Our Ref: Response to December 2024 RFI - GHG_20250116

RE: Request for Additional Information – Consideration of Climate Change (Net Zero Future) Act 2023

The Chain Valley Colliery Consolidation Project (The Project) includes the consolidation of approval requirements for the existing Chain Valley Colliery and Mannering Colliery under a single consent, as well as the continuation of existing mining operations for an additional two years beyond the current approval of 31 December 2027 to 31 December 2029.

Figure 1: An example of a relationship between gas make and coal mined for the “active mining area”

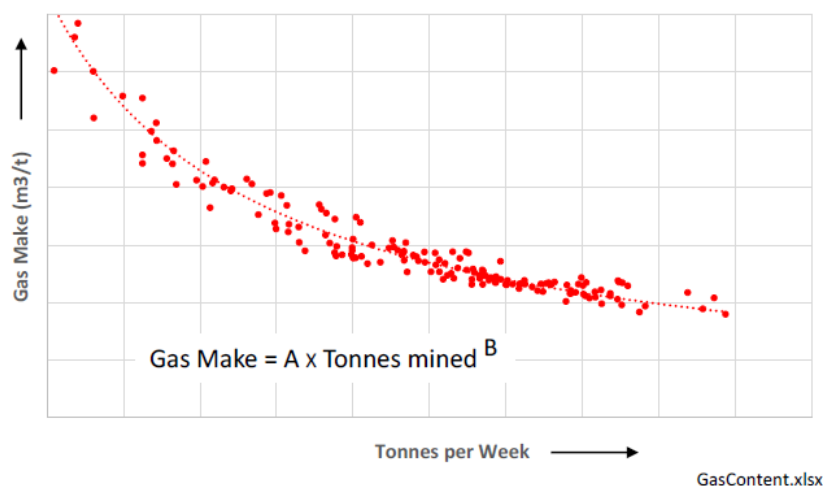
Of the above, Scope 1 emissions associated with ventilation activities represents the most significant potential source of emissions from the Project in 2030. The GHG emissions are released to the atmosphere via ventilation fans and would be expected to be significantly lower than during operations due to the declining rate of gas make from mined areas (as discussed in Section 3.2 of the IEAPM advice to DPHI on the Greenhouse Gas Assessment and summarised in Figure 1 from that report, extracted in **Figure 1** below) (IEAPM, 2024a) and the ability to seal off inactive mining areas and reduce fugitive emissions from those areas being released via the ventilation system.

As noted above, the costs associated with ongoing ventilation of underground workings are a significant cost to the operation and there is a strong financial incentive for workings to be sealed to reduce these ventilation costs, which would have corresponding benefits in terms of significantly reducing emissions.
